6.3.03 External Envelope Amendments (arising from internal layout changes)

8.11 Consented and Proposed Comparison Elevations

Kenavon Drive
East Block South Elevation

Kenavon Drive
East Block East

Layout Changes with Elevational Impacts
Isometric View from North

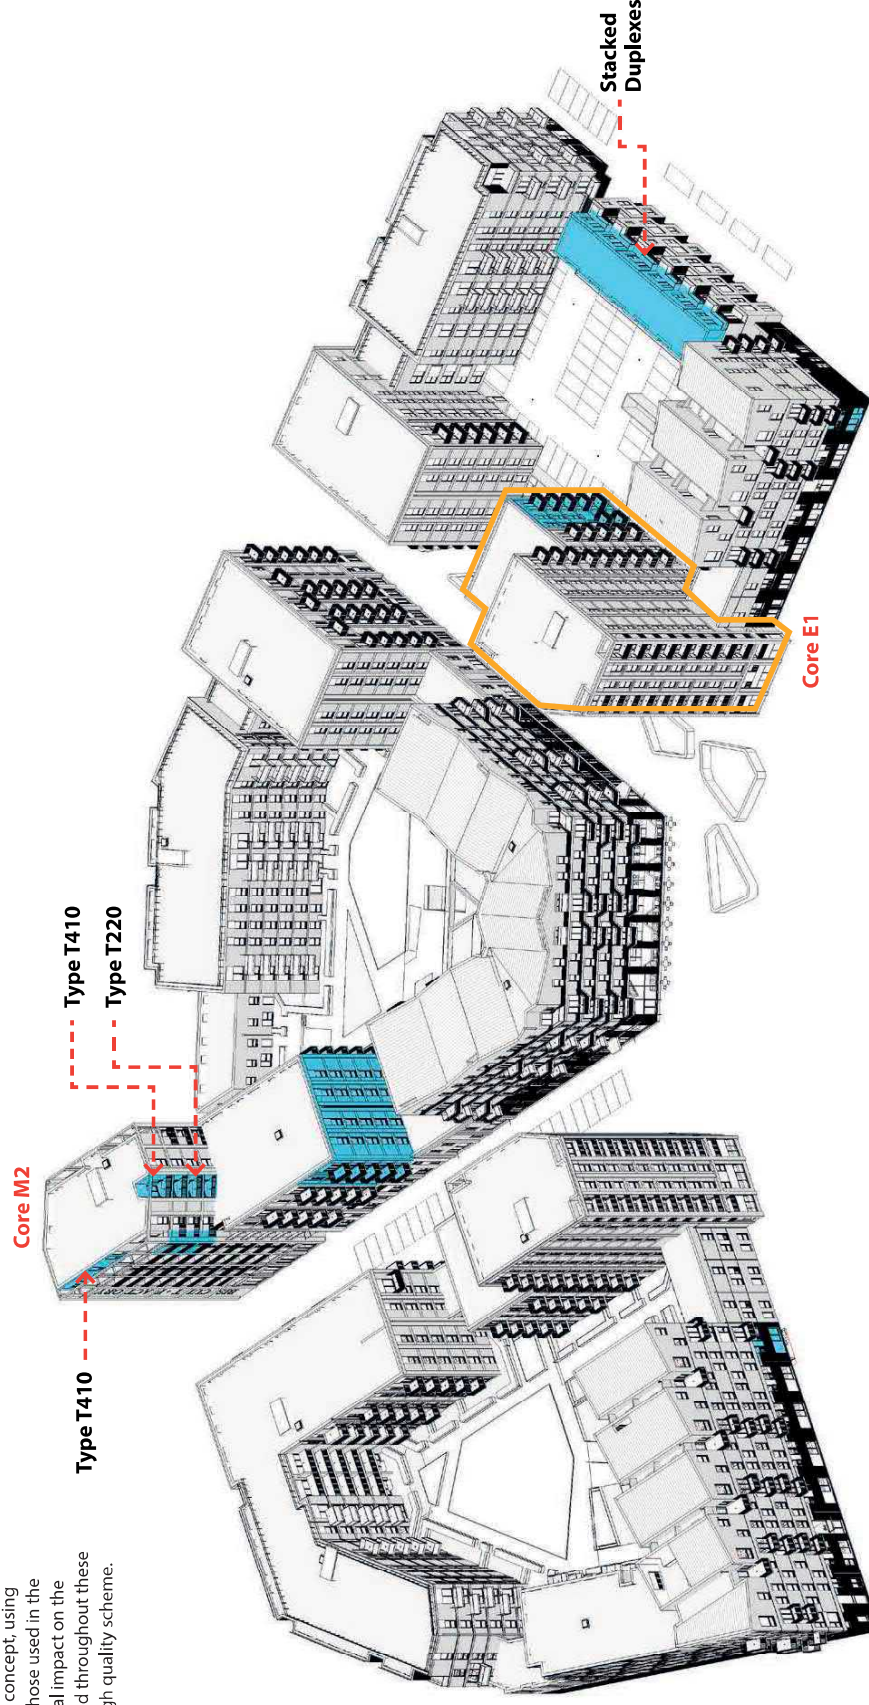
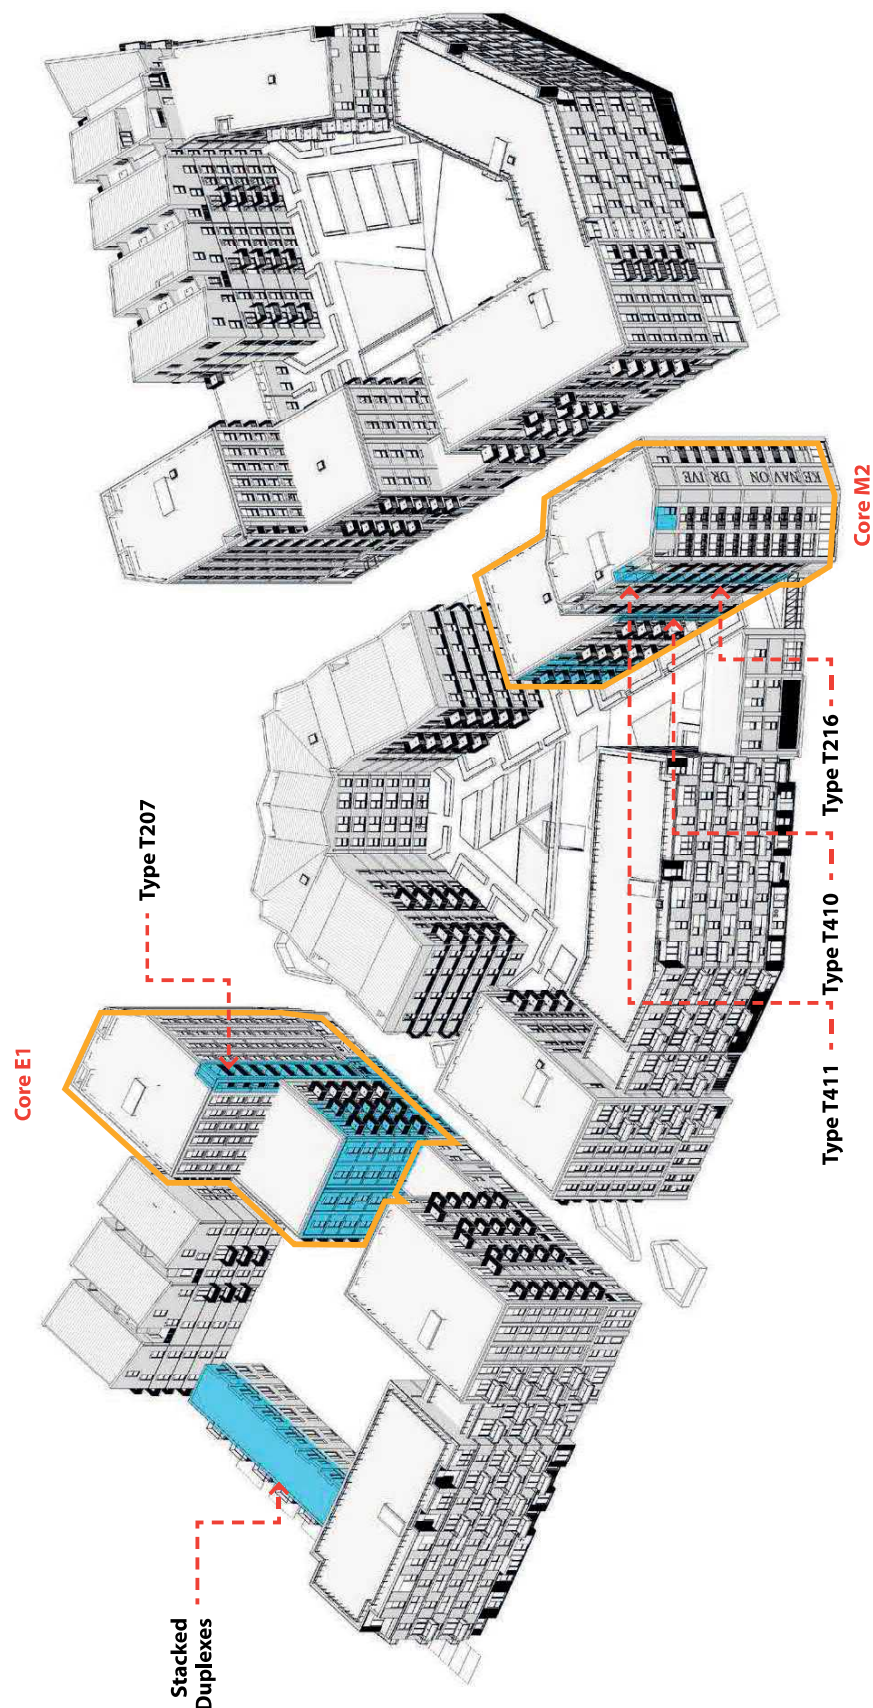
Amended area as result of internal layout changes

Extended window opening
Column omitted
Recessed corner infilled

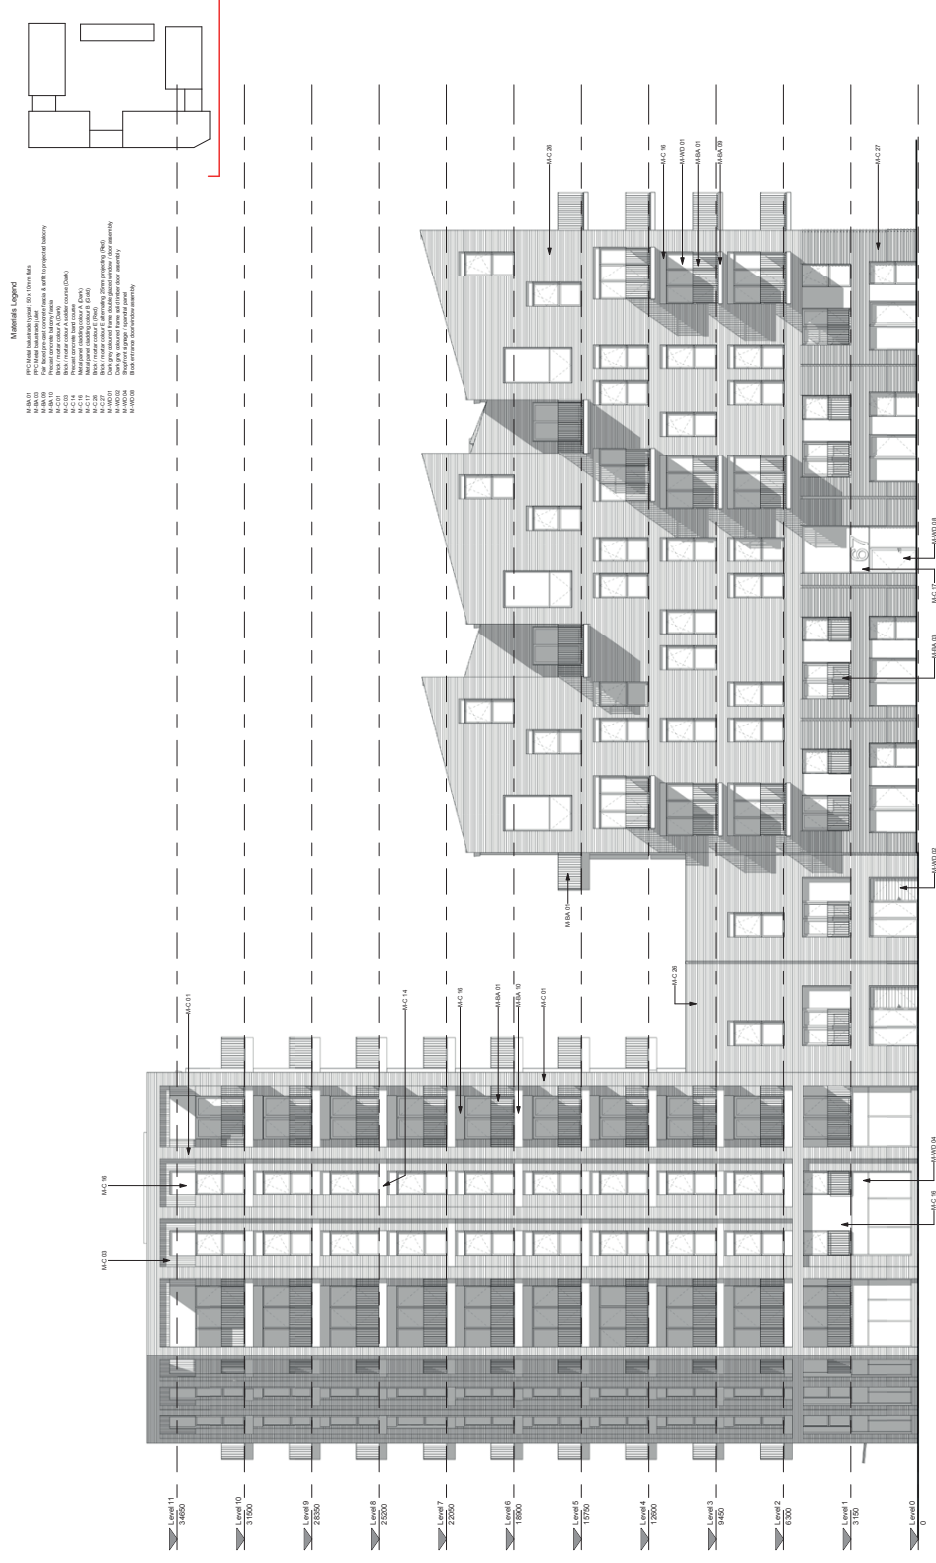
Amended area as result of internal layout changes

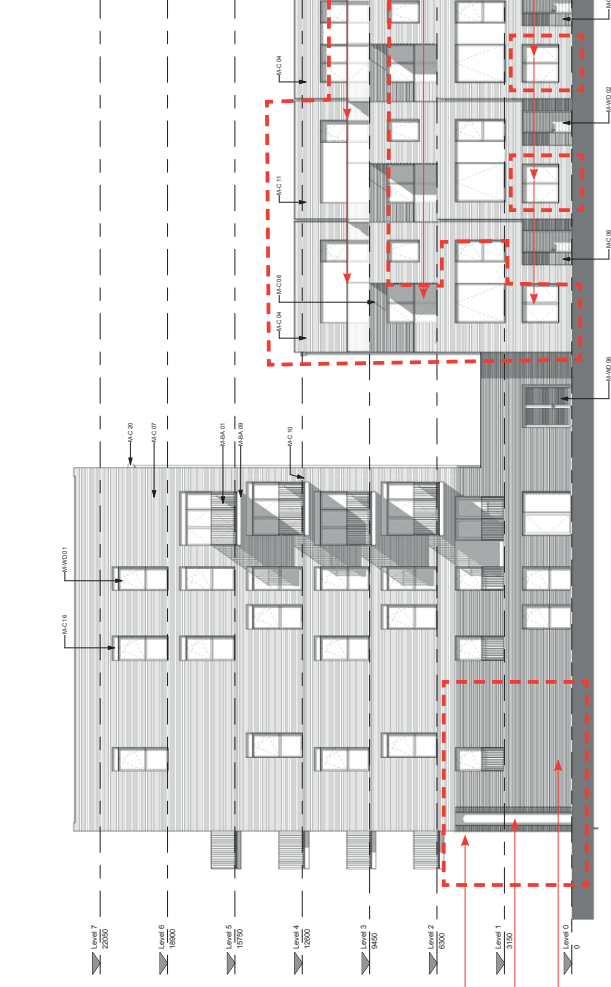
Recessed corner infilled

Column omitted

Window added

- Top floor facade brought forward to increase internal floor area and reduce terraces

- Fenestration amended from 2 pane to 4 pane

Amended doors and windows width on la house to equalise bri piers

Amended ground floor
windows to patio doors to
provide access to front
gardens

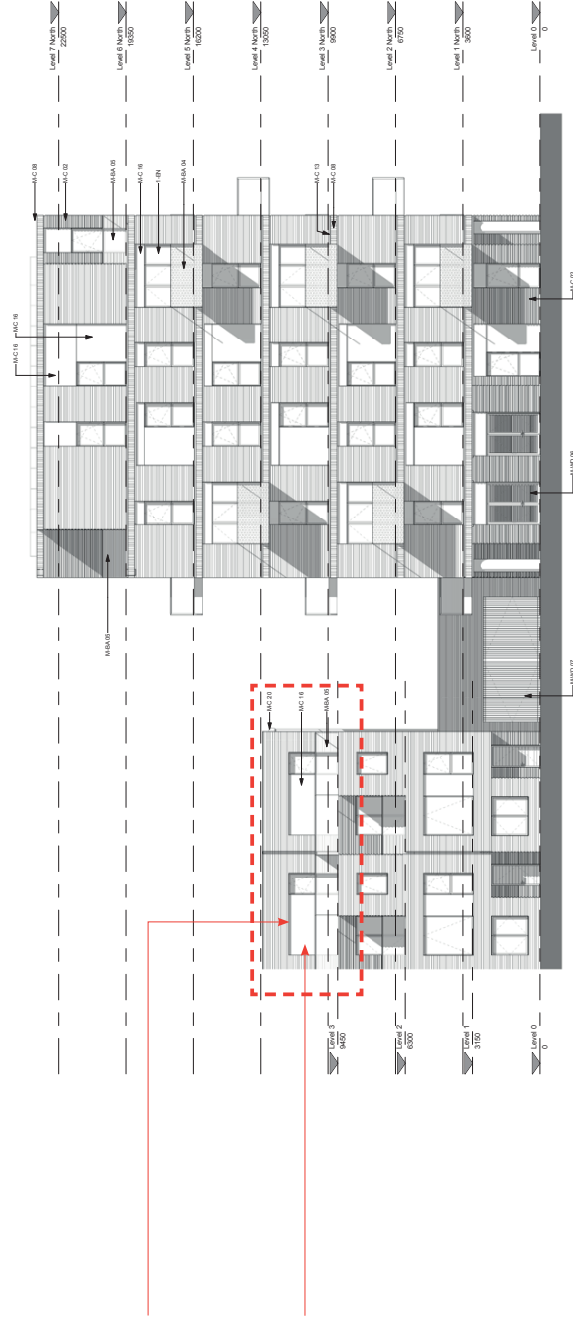
Top floor facade brought forward to increase internal floor area and reduce terraces

Fenestration amended
from 2 pane to 4 pane
